KENTUCKY-AMERICAN WATER COMPANY
CASE NO. 2023-00248
CITY OF PARIS'S SECOND REQUEST FOR INFORMATION

Main South of Paris – Existing Main Upsizing

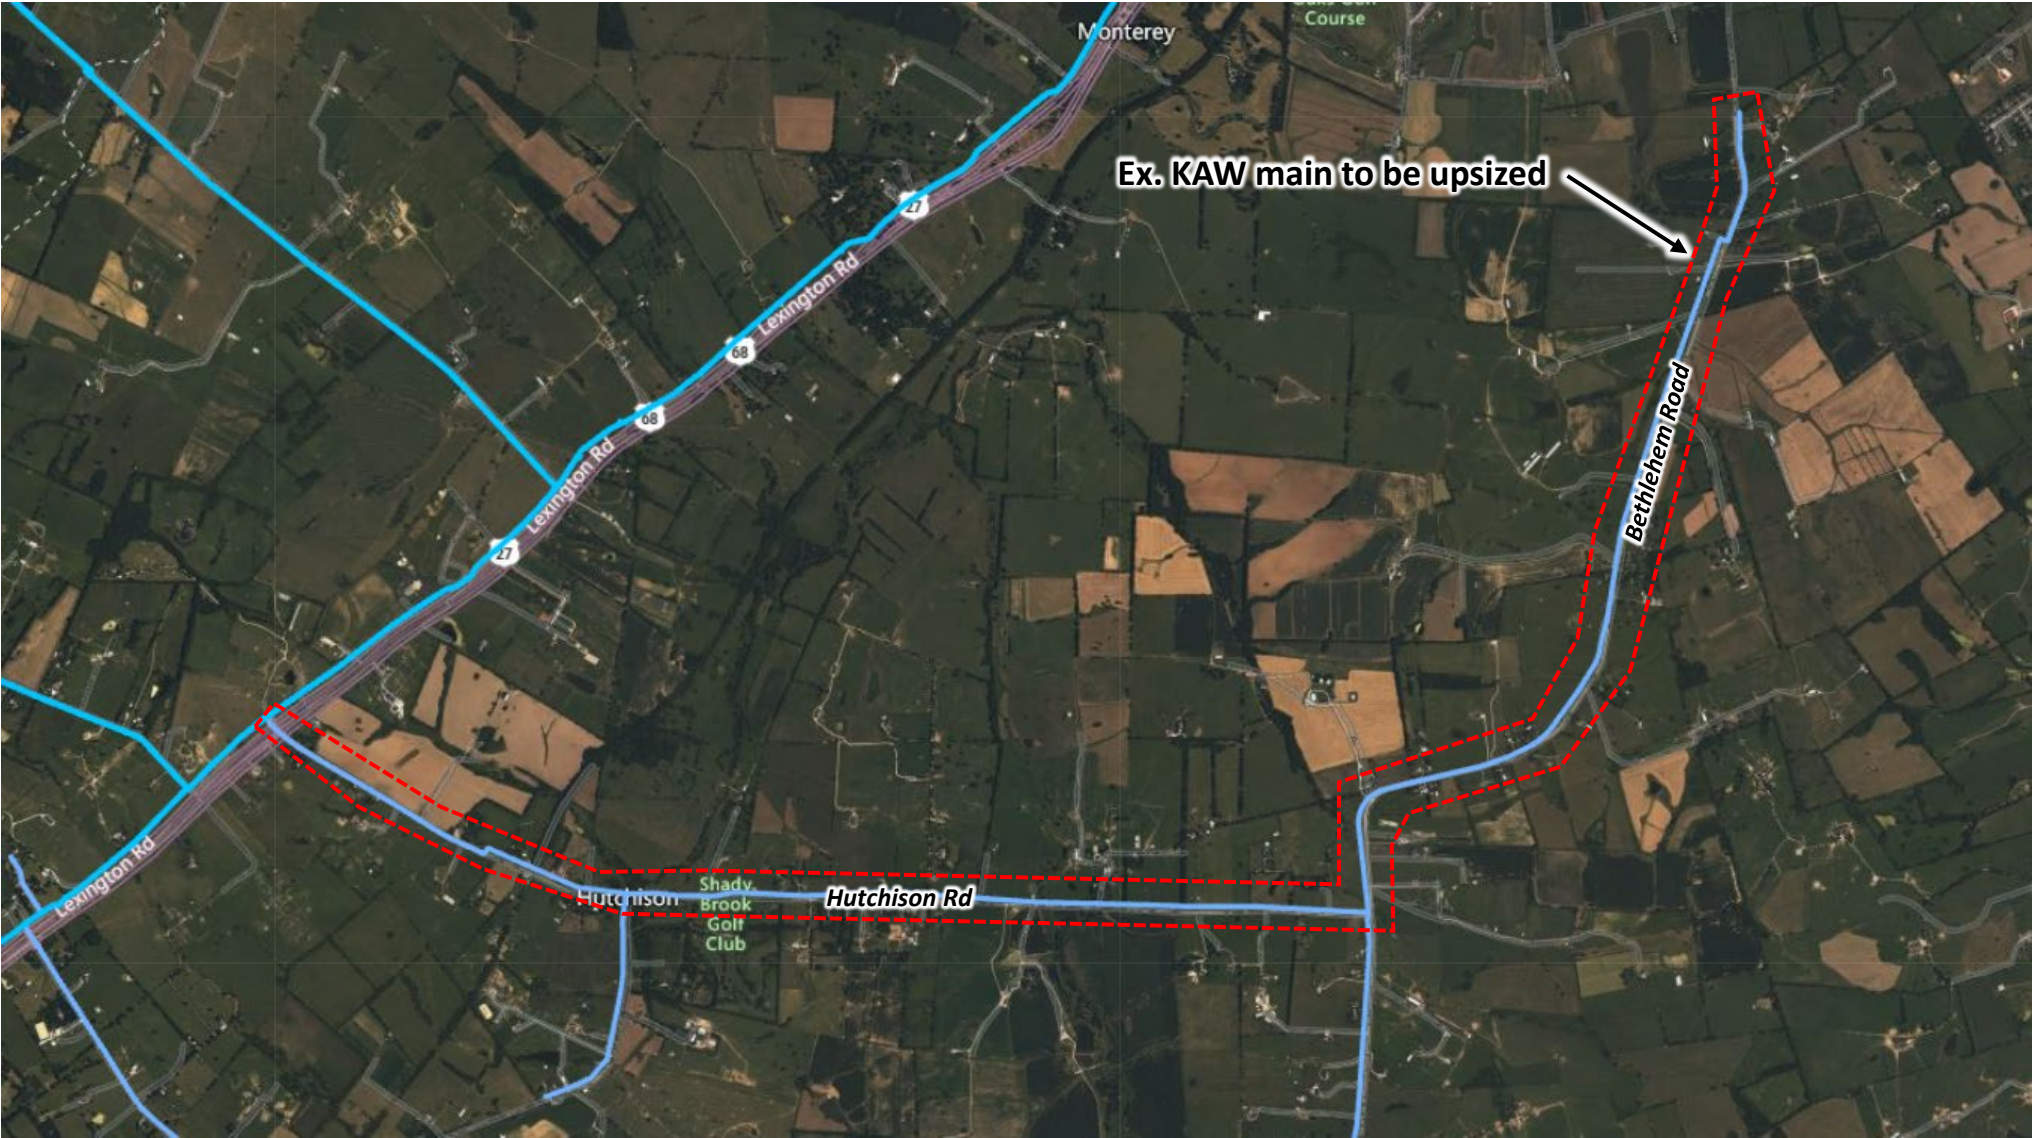
8. Please refer to KAW's Response to Paris 1-12(c). Identify the estimated cost for upsizing approximately six miles of existing 8" KAW main between US-68 and Bethlehem Road. Provide all assumptions on which this estimate is based.

Response:

Please see the attached.

Planning Cost Estimate						
Proj.	Main South of Paris - Upsize Existing Main					
Date:	9/22/2023					
No.	Item	Unit	Quantity	Unit Price*	Total Cost	Notes/Assumptions
Engineering/Design					\$ 200,000	
1	Consultant Design Fee	LS	1	\$ 200,000	\$ 200,000	Approx. 50% of design fee for currently proposed main
Materials					\$ 1,922,500	
2	12" Ductile Iron Pipe	LF	0	\$ 40	\$ -	
3	16" Ductile Iron Pipe	LF	32,000	\$ 55	\$ 1,760,000	Assumes upsizing to 16" main
4	Gate Valve	EA	22	\$ 7,000	\$ 154,000	Replacement of existing valves
5	22.5° Bend	EA	0	\$ 350	\$ -	
6	45° Bend	EA	0	\$ 350	\$ -	
7	90° Bend	EA	1	\$ 500	\$ 500	
8	Air Release Valve	EA	5	\$ 400	\$ 2,000	Install ARV's at significant high points
9	Hydrant	EA	4	\$ 1,500	\$ 6,000	Replacement of existing hydrants
Construction Labor					\$ 2,586,450	
10	Mobilization/Demobilization	LS	1	\$ 120,000	\$ 120,000	Approx. 5% of construction labor cost
11	Traffic Control	LS	1	\$ 75,000	\$ 75,000	Assumed

12	Pipe Installation - Rural/ROW	LF	31,550	\$ 65	\$ 2,050,750	
13	Pipe Installation - Roadway	LF	0	\$ 170	\$ -	
14	Pipe Installation - Road Crossing	LF	350	\$ 700	\$ 245,000	
15	Pipe Installation - Creek Crossing	LF	100	\$ 600	\$ 60,000	
16	Pipe Installation - Railroad Crossing	LF	0	\$ 1,500	\$ -	
17	Valve Installation	EA	27	\$ 600	\$ 16,200	
18	Hydrant Installation	EA	4	\$ 3,000	\$ 12,000	
19	Tie-in	EA	3	\$ 2,500	\$ 7,500	Reconnect three existing mains to upsized main
Overhead/Legal/Easements					\$ 830,000	
20	AFUDC	LS	1	\$ 130,000	\$ 130,000	Approx. 3% of material and construction labor costs
21	Overhead	LS	1	\$ 450,000	\$ 450,000	Approx. 10% of material and construction labor costs
22	Legal/Easements	LS	1	\$ 250,000	\$ 250,000	Approx. 50% of estimated fees for currently proposed main
Project Total					\$ 5,538,950

*Unit prices, except for lump sum items, are identical to those used in the development of the cost estimate for the proposed project which was provided as Exhibit 4 to the direct testimony of John Magner.
